ADDENDUM

Project: **Crestwood School District
Crestwood High School
Field Building & Site Improvements**

Date: **March 27, 2023**

Addendum Number: **#2**

M2.01

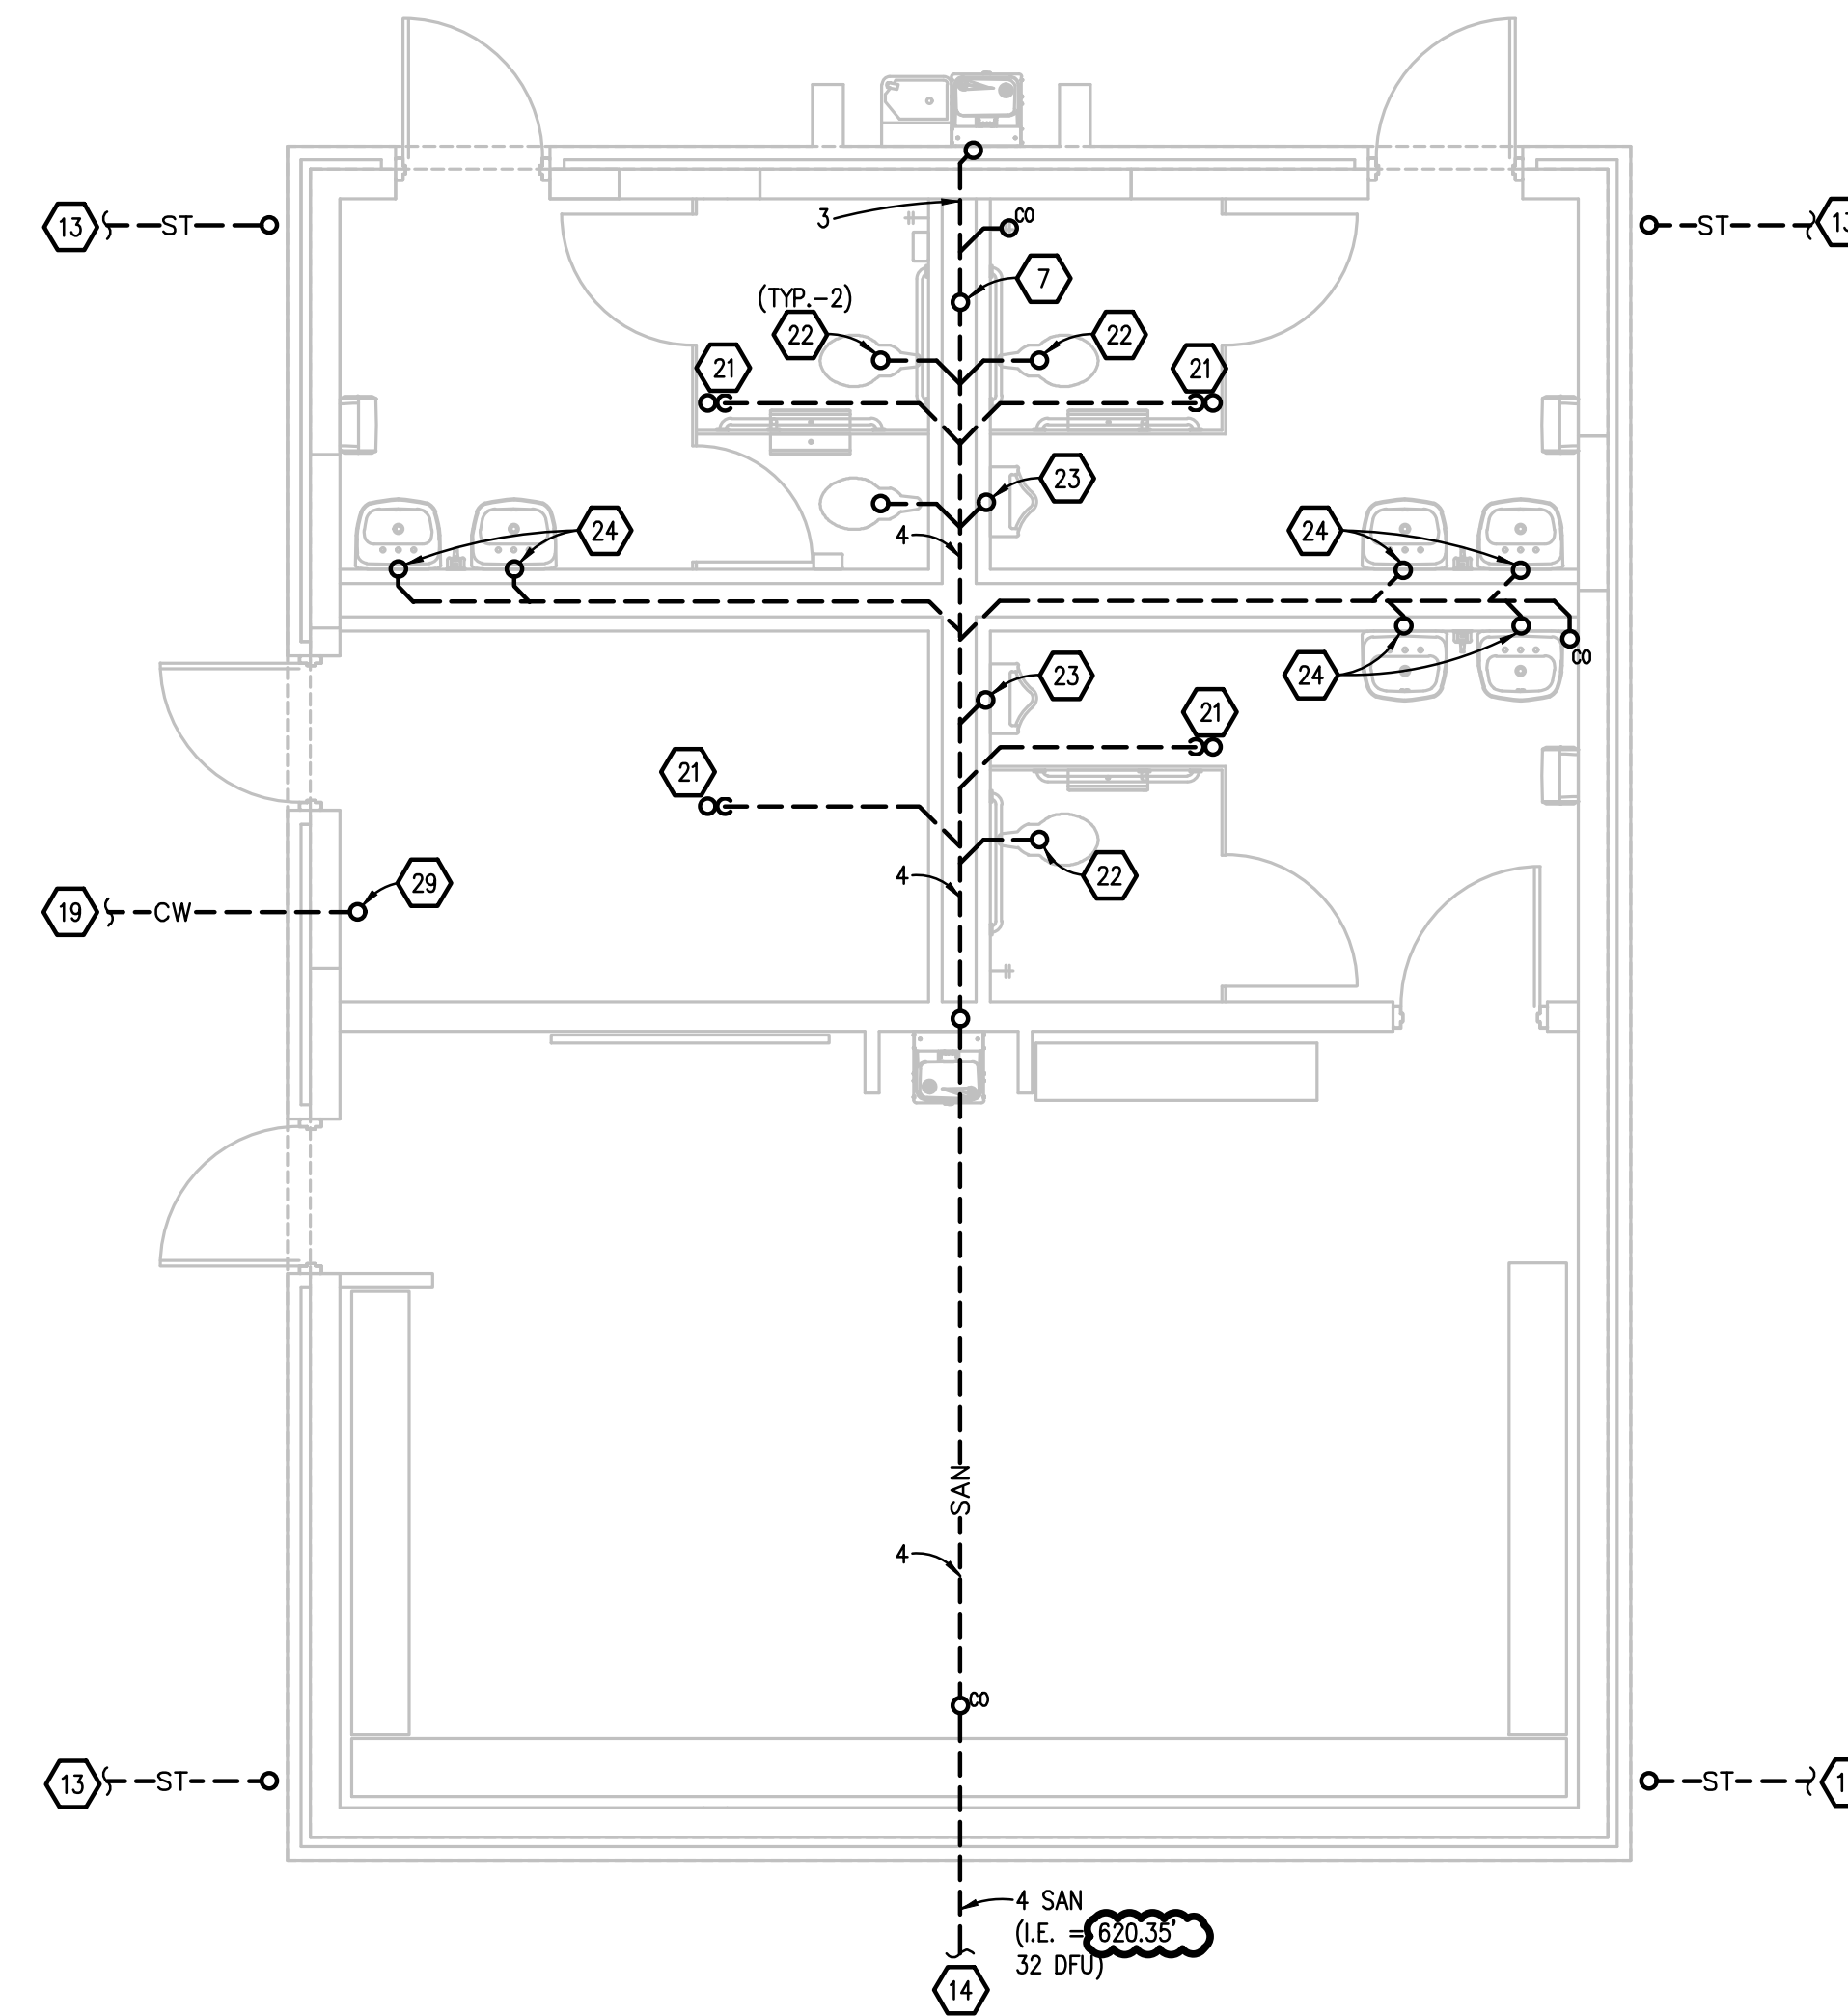
MD-1 Refer to Drawing M2.00 & M2.01 (Re-Issued)

1. Clarify Invert elevation of sanitary lead at Building A & B, as indicated.
